IOWA ARMY AMMUNITION PLANT

PROPOSED PLAN FOR TRENCH 6, TRENCH 7, AND THE CAP EXTENSION AREA OF THE INERT DISPOSAL AREA (IDA)

OPERABLE UNIT FOUR

RESPONSE TO USACHPPM COMMENTS
23 MARCH 2007

Figure 3 – Typical Cross Section of the Caps

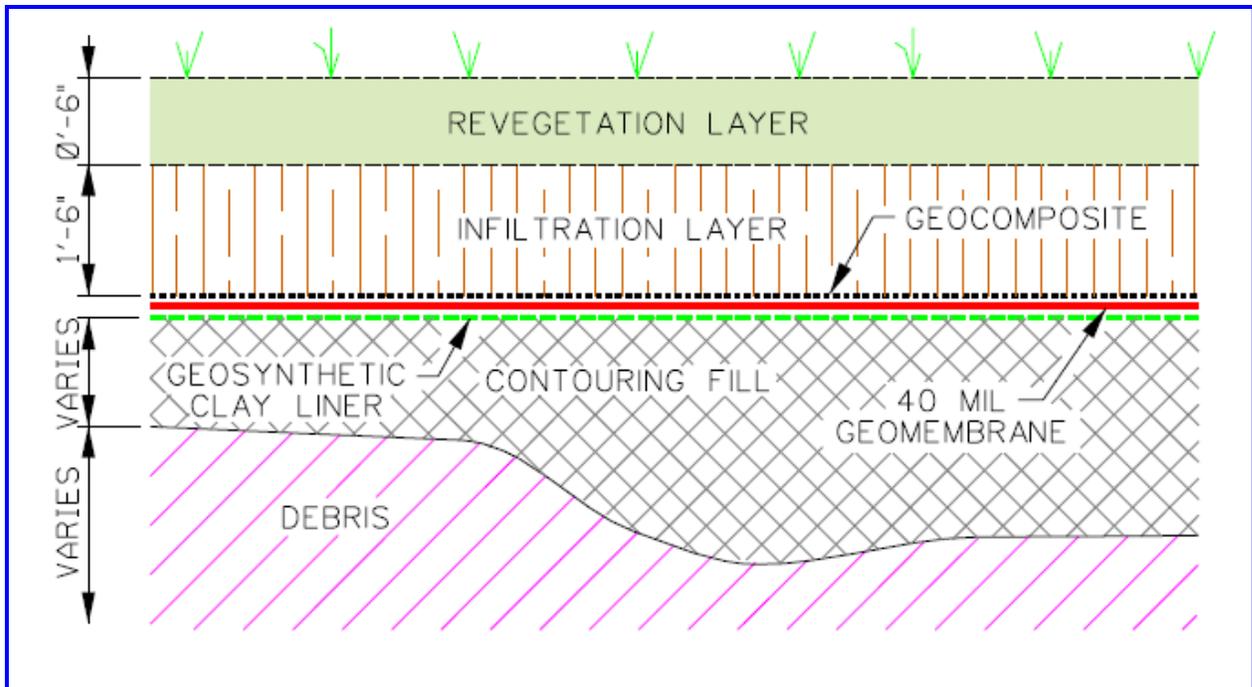
12.	Page 9 Summary of Remedial alternatives	Is this one contiguous cap – show cap design (approx) on fig	The caps on Trench 6 and CEA are separate. CEA is adjacent to ILF. Figure 3 shows detail of the cap design.

14.	Page 10 Summary of remedial alternatives	Fig 3 is not too helpful	Figure 3 has been modified to show the different layers in cap design.
15.	Page 11 Remedial alternative evaluation	Not an Iowa but a fed requirement	Agreed. The correction has been made.
